JRPP PLANNING REPORT (FURTHER REPORT)

JRPP NO:	2012SYW030
DA NUMBER:	870/2012/JP
LOCAL GOVERNMENT AREA:	THE HILLS SHIRE COUNCIL
PROPOSED DEVELOPMENT:	RESIDENTIAL FLAT BUILDING AND MULTI DWELLING HOUSING DEVELOPMENT
STREET ADDRESS:	NOS. 40-52 BARINA DOWNS ROAD, BAULKHAM HILLS
APPLICANT/OWNER:	MERFAD PTY LIMITED
NUMBER OF SUBMISSIONS:	FIRST NOTIFICATION PERIOD: 28 SUBMISSIONS SECOND NOTIFICATION PERIOD: 9 SUBMISSIONS THIRD NOTIFICATION PERIOD: 2 SUBMISSIONS
RECOMMENDATION:	APPROVAL
REPORT BY:	DEVELOPMENT ASSESSMENT CO-ORDINATOR GAVIN CHERRY

Previous Northern Elevation

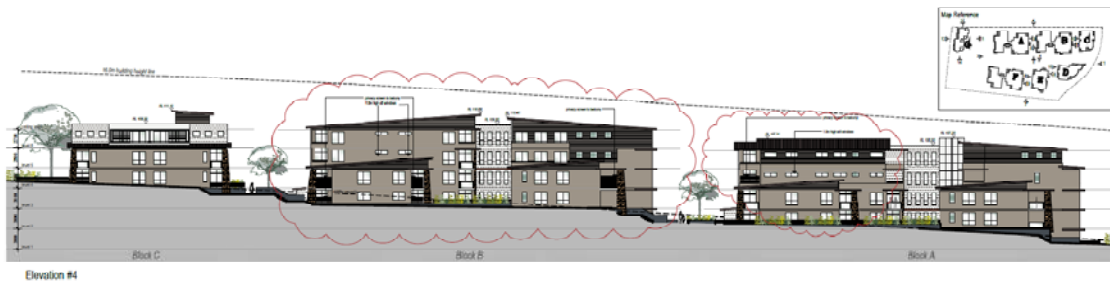
- Building A: The southern portion of Level 4 and Level 5 have been amended to provide greater upper level separation to the northern adjoining properties. The amended setback at this location is now 15.59m whereas the previous proposal was 11.78m. The amendments have resulted in a two storey interface at the lower levels of the building.

- Building B: Level 5 and Level 6 have been amended to provide greater upper level separation to the northern adjoining properties. The amended setback for Level 4 and 5 is now 13.2m and 12.84m whereas the previous proposal was 6.7m and 7.0m. The amendments have resulted in a two storey interface at the lower levels of the building. The resulting amended upper floor setbacks are also considered to provide an improved transition between Buildings A, B and C as viewed from the adjacent northern properties.

- Building E: Level 5 and Level 6 have been amended to provide greater upper level separation to the southern adjoining properties. The amended setback for Level 5 and 6 is now 16.96m and 12.84m whereas the previous proposal was between 9.0m and 13.445m. The amendments have resulted in a two storey interface at the lower levels of the building. The resulting amended upper floor setbacks are also considered to provide an improved transition between Buildings D, E and F as viewed from the adjacent northern properties.

- Building F: The southern portion of Level 4 and Level 5 have been amended to provide greater upper level separation to the southern adjoining properties. The amended setback at this location is now 14.840m whereas the previous proposal was 11.030m. The amendments have resulted in a two storey interface at the lower levels of the building. The proposed amendments are considered to be consistent with the deferral requirements of the JRPP and satisfactory.

A comparative analysis of the previous and now amended northern and southern elevations is provided below:-

The proposed amended development has adopted the recommendations of the JRPP by amending the design of Buildings B and E as well as the southern portions of Buildings A and F. As detailed above, the applicant has amended the proposed development to provide an improved stepped interface between the residential flat buildings and the adjacent single and two storey residential dwellings. The amendments result in a two storey interface for all amended buildings at the ground and first floor (as viewed from the neighbouring dwellings) with all upper levels set back well in excess of the DCP requirements. This amendment provides improved integration with the surrounding low density character of the area whilst enabling additional built form to be accommodated within the central depression of the site.

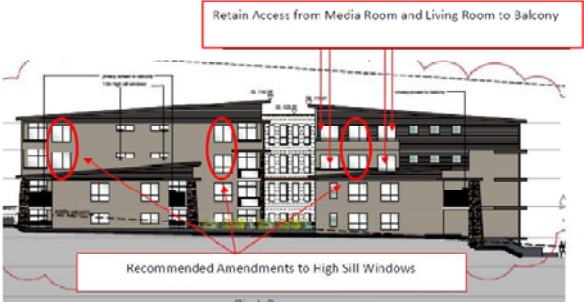
It appears that the	Level 5 and Level 6 of the northern portion of	Issue

ISSUE/OBJECTION	COMMENT	OUTCOME
<p>developer has ignored the JRPP ruling on the southern part of building B. It appears that little or no effort has gone into addressing the privacy concerns.</p>	<p>Building B facing the adjacent properties (Elevation 4) are not consistent with the upper floor windows proposed for Buildings A, E and F.</p> <p>The proposed windows for Building B are as follows:-</p>  <p>The proposed upper floor windows for Building A (for comparison) are as follows:-</p>  <p>As such it is considered appropriate to condition Level 5 and 6 of Building B (Elevation 4) to provide high sill windows as per the other proposed buildings as amended in red below:-</p>  <p>It is considered that the proposed amended setbacks for Levels 5 and 6 of Building B have satisfied the deferral requirements of the Joint Regional Planning Panel. It is also considered that the above suggested amendments in red will ensure that the window and privacy treatments to this building are consistent with that proposed for Building A, E and F. It is also noted that these levels provide an external wall setback of 13.2m (balcony set back 10.710m) which is well in excess of the DCP required side boundary set back of 6.0m.</p>	<p>addressed. Refer to Condition No. 1 for recommended amendments in red.</p>

ATTACHMENT A2 – AMENDED ELEVATION DRAWINGS

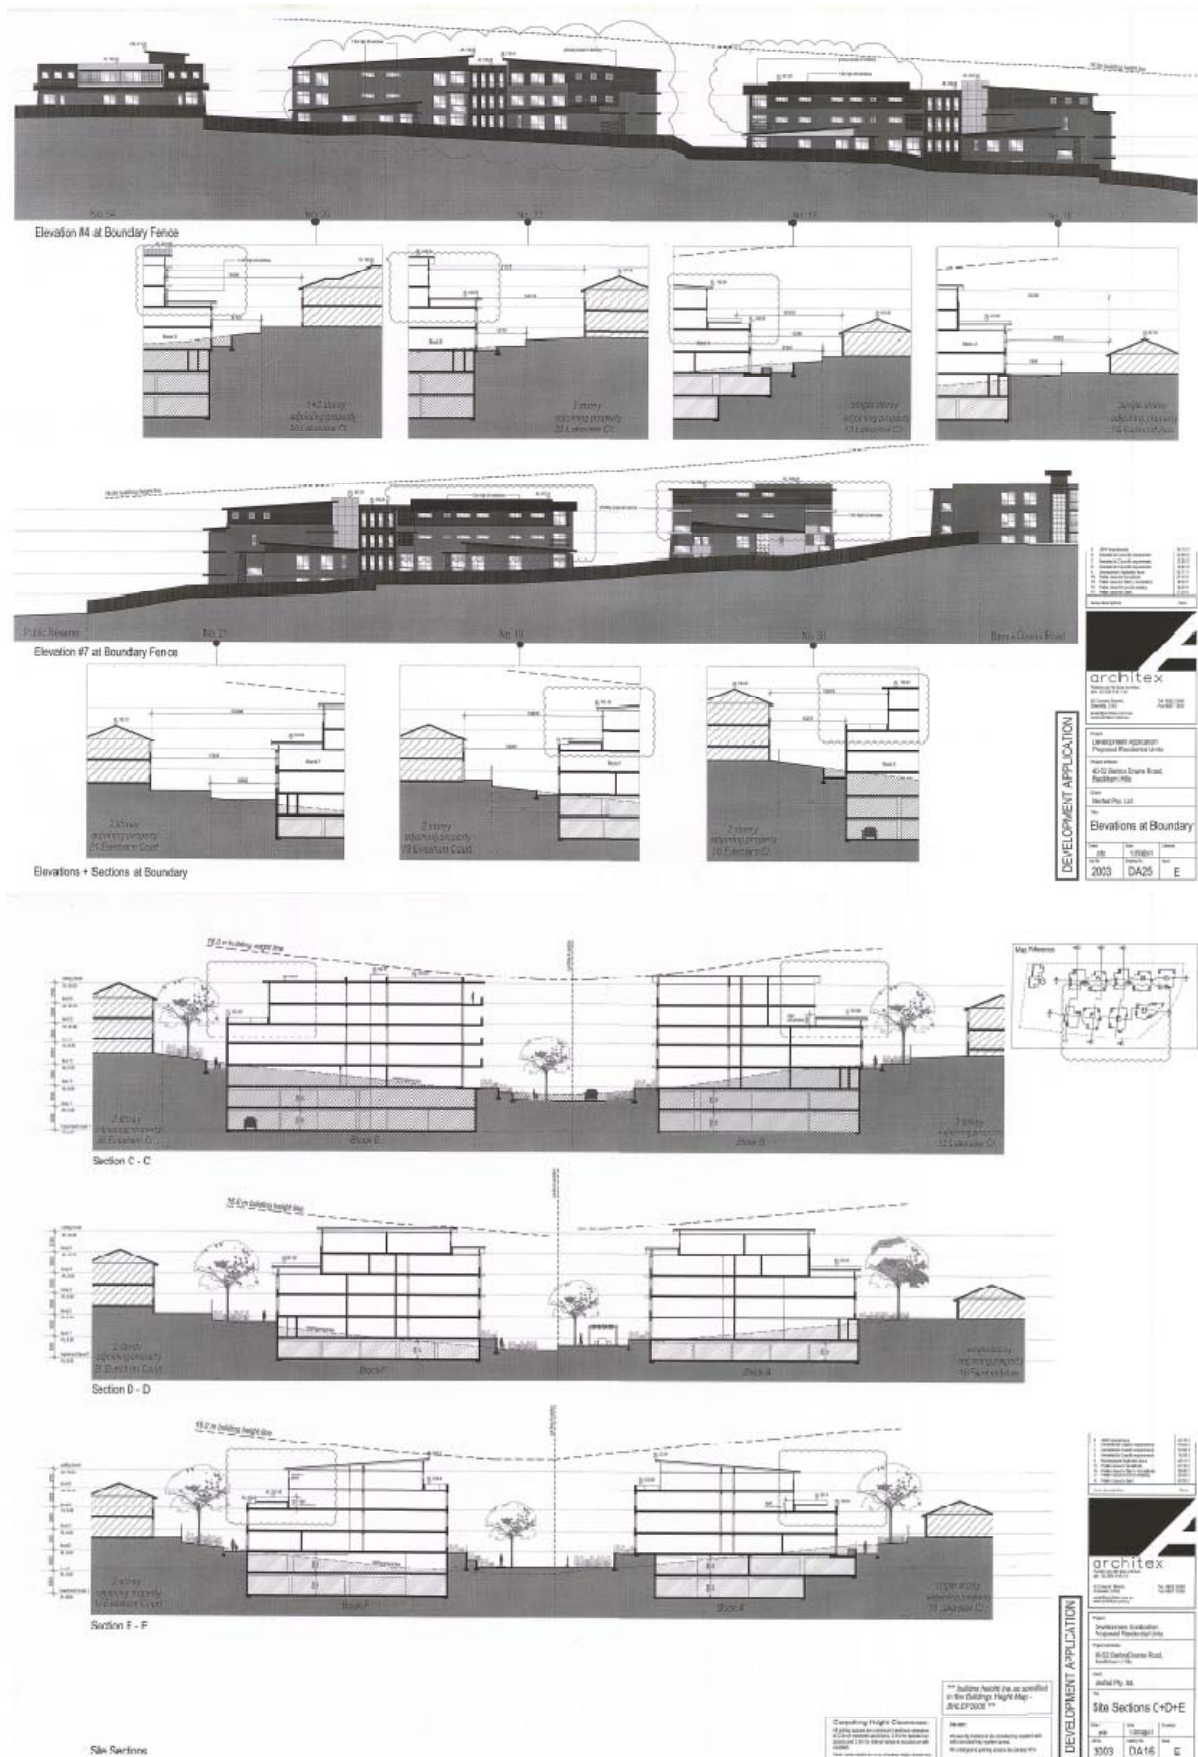
"The decision is to defer the application for submission of amended plans that will replicate the design of the northern portion of buildings A & F, specifically in relation to the number of stories and setbacks, to deal with the panel concerns about the impact of bulk and scale. These plans are also to deal with appropriate window treatment and balcony screening to ensure adequate privacy for the neighbouring properties. The plans to be changed are for buildings B & E and the southern portion of A & F. The plans are to be submitted within 14 days of the panel's notification of its determination.
